SCITUATE PLANNING BOARD MINUTES December 14, 2023

Continued - Public Hearing – Major Site Plan Review and Stormwater Permit – Stearns Meadow – Water Treatment Plant – 453 CJC Hwy
Assessor's Map/Block/Lot 47-2-26-J
Applicant/Owner: Town of Scituate

Stearns Meadow Drinking Water Treatment Plant

Construction Phase Stormwater and Dewatering

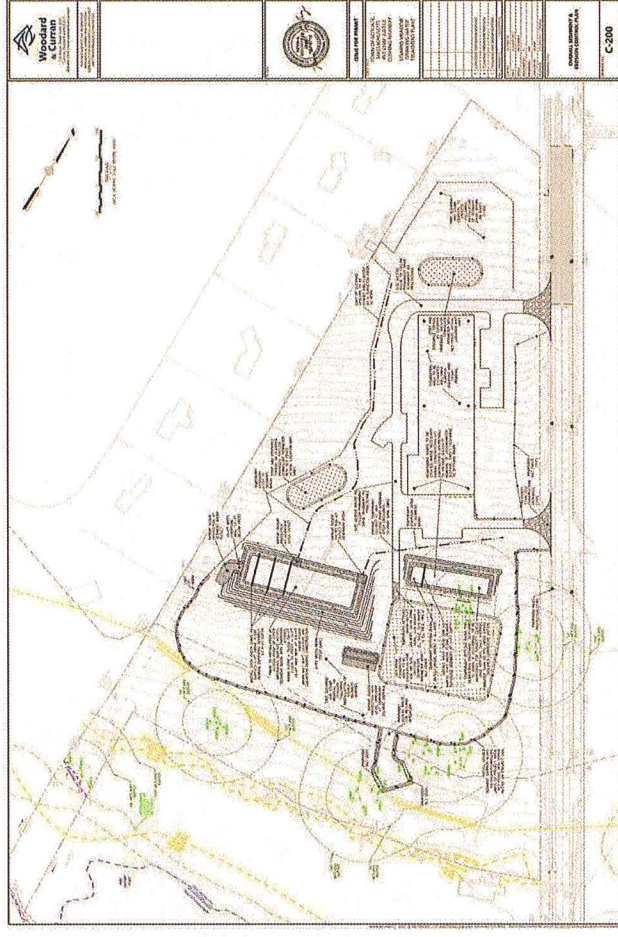
Mr. Pritchard also commented that the expectation that during periods of high ground water the under-foundation drains would be running 100% of the time and discharging at the two locations over land. Mr. Robbins said the dewatering flows at a steady state and their geotechnical engineer says it could be 10 gallons/minute. Mr. Pritchard said it would be feeding down towards the property; he wants to make sure it is not going to other people's property at the property line and not creating a swamp. Mr. Robbins said it is feeding in the natural direction of groundwater flow and ultimately to the revisor.

Add condition 61 – the applicant shall evaluate the performance of the dewatering system to make sure there are no overland impacts to the neighboring properties.

Grading and Drainage Plan

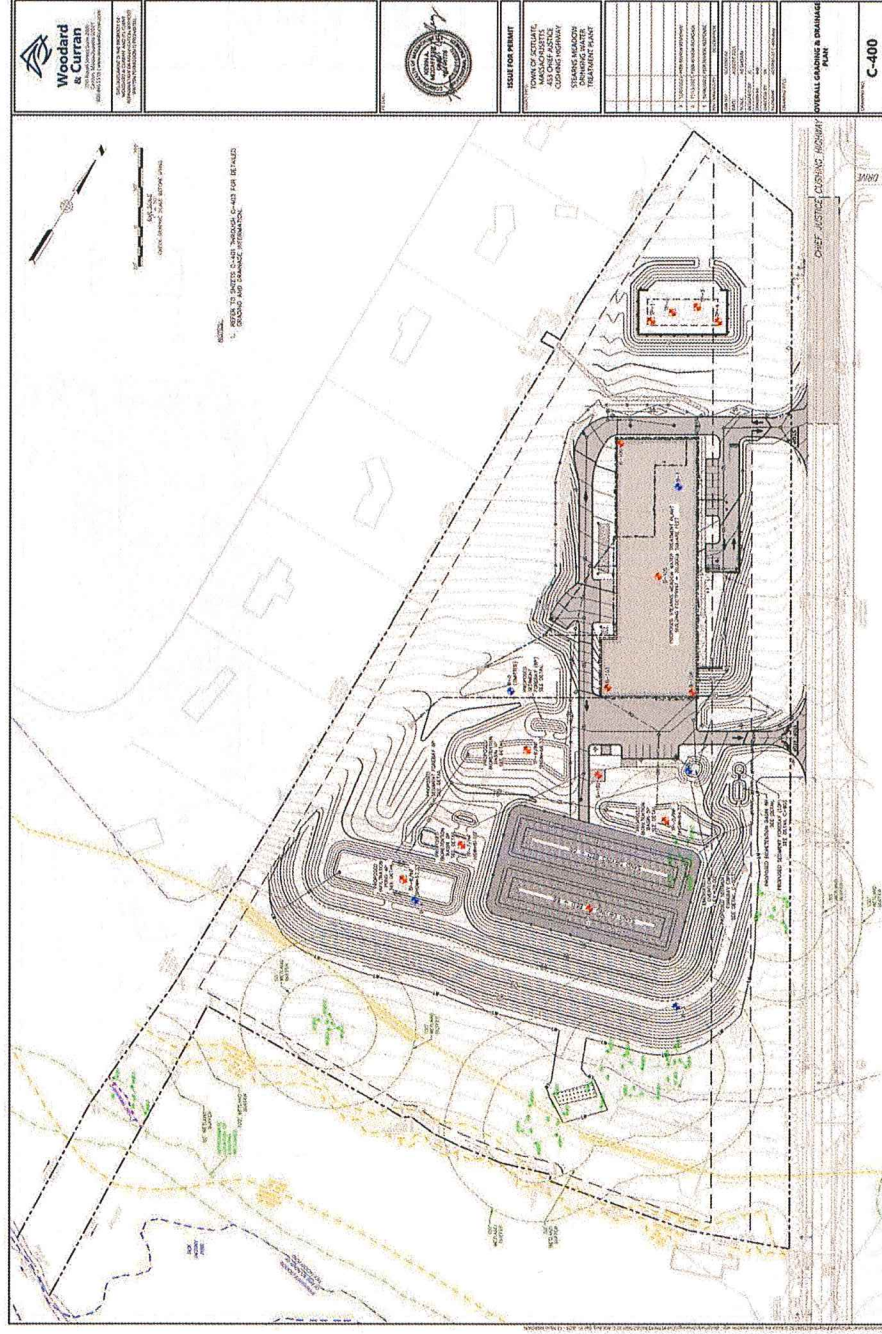
Mr. Pritchard said there are three groundwater outlet points on the drawing and one looks like the outlet is higher than the inlet and one looks like it is under the foundation of the building and asked for explanation on how that works. Mr. Stanley pointed out the location of the drains on the plan and explained that there is a high point in the middle of the building and it drains outward to a point he specified on the plan as well as another drain that he pointed out on the plan and the direction in which it drains. Mr. Pritchard questioned that the outlet points to one of those drains appears to be higher and he does not understand how that works. He provided the elevations and said he is trying to figure out how the water is going to flow up hill. Mr. Stanley said that is an oversight that was not addressed, but if it needs to be adjusted they will; there was discussion that if there needs to be an adjustment the outlet would come down to the swale where it is going anyways. Mr. Robbins said the invert maybe incorrect and they will double check it.

Mr. Pritchard asked what is underdrain outlet #3 that is noted on the plan on the foundation line on the south end. Mr. Robbins said they will check on it and get back to the Board; there is no intention for anything to be pumped. Mr. Pritchard was referring to detail sheet #401.

Mr. Stanley indicated there were some errors with elevations on the drawings that will be corrected; it is drawn correctly they are not labeled correctly. He also said the proposed underdrain outlet #3 that Mr. Pritchard had referred is also incorrect and must have been copied over from a previous drawing. The drawings will be corrected.

Add condition 60 – a revised set of plans shall be submitted to the Planning Board prior to a Building Permit application to show correct rims/inverts/outlet elevations for underdrains, the revised limit of work for the wetland mitigation area and a revised Operation and Maintenance Plan if necessary.
